ATTACHMENT 1A

Emergency Plan Marked-up Pages – Braidwood Station

Exelon Standardized Emergency Plan EP-AA-1000
and
Emergency Plan Annex EP-AA-1001

Affected Pages – Marked-up

Figure B-1b: Emergency Onsite Organization

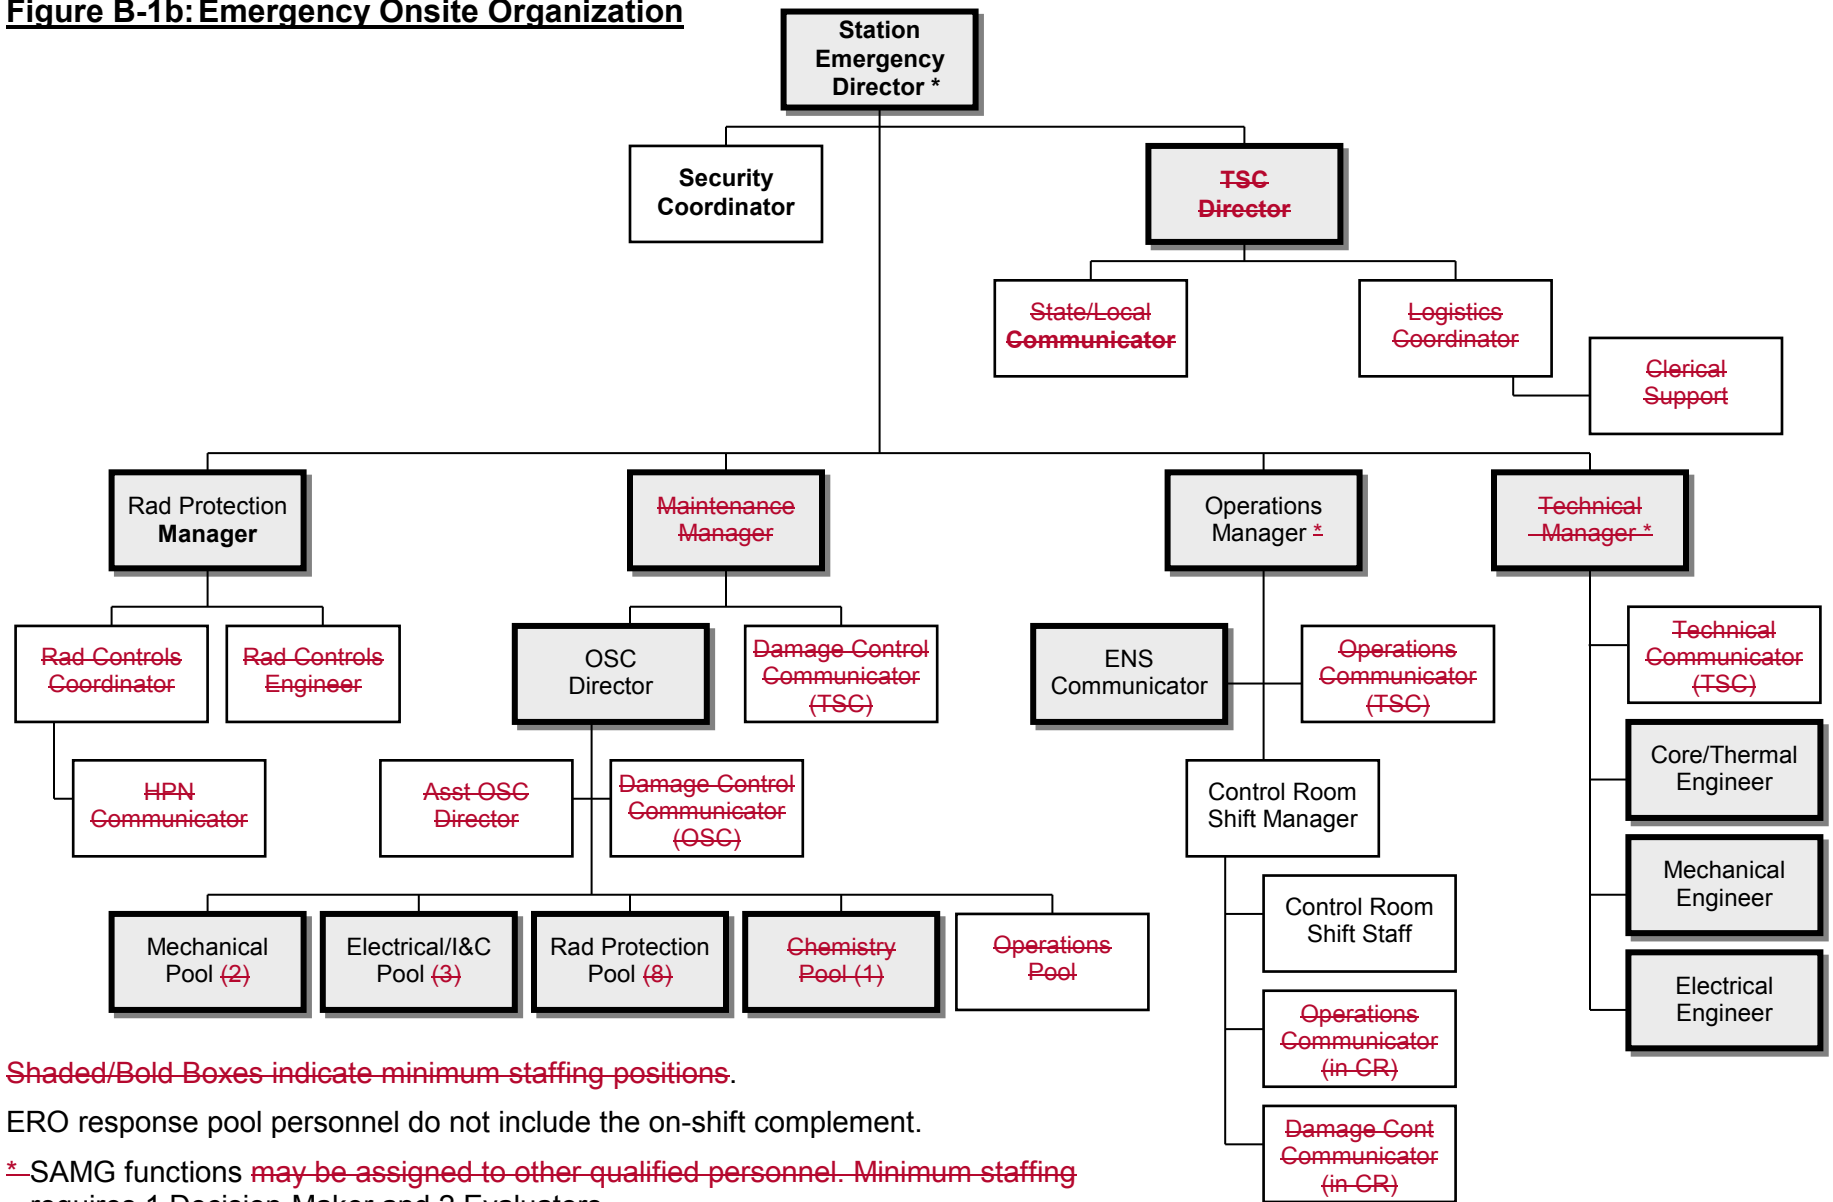
Shaded/Bold Boxes indicate minimum staffing positions.

ERO response pool personnel do not include the on-shift complement.

*-SAMG functions may be assigned to other qualified personnel. Minimum staffing requires 1 Decision-Maker and 2 Evaluators.

Figure F-3: NRC Communications for Nuclear Response

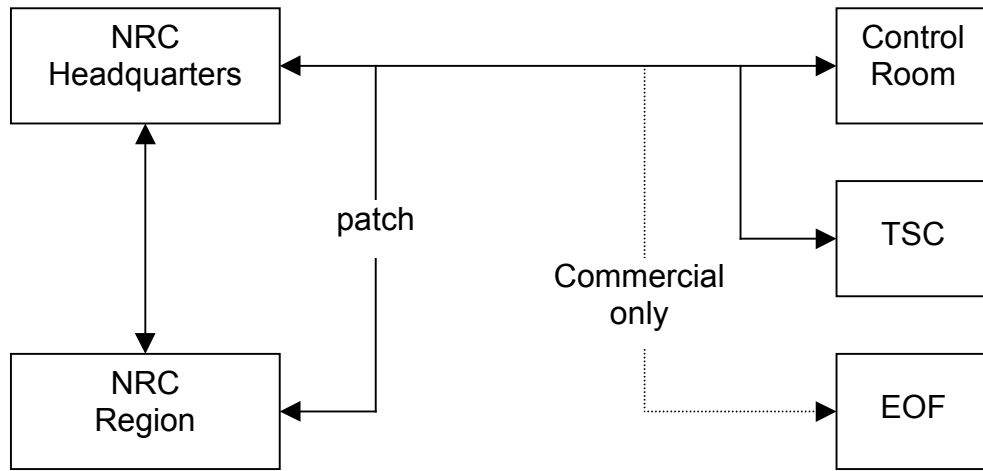
~~Health Physics Network (HPN): There also exists a separate dedicated telephone between the NRC, the TSC, and EOF for conveying health physics information to the NRC as requested or as an open line.~~
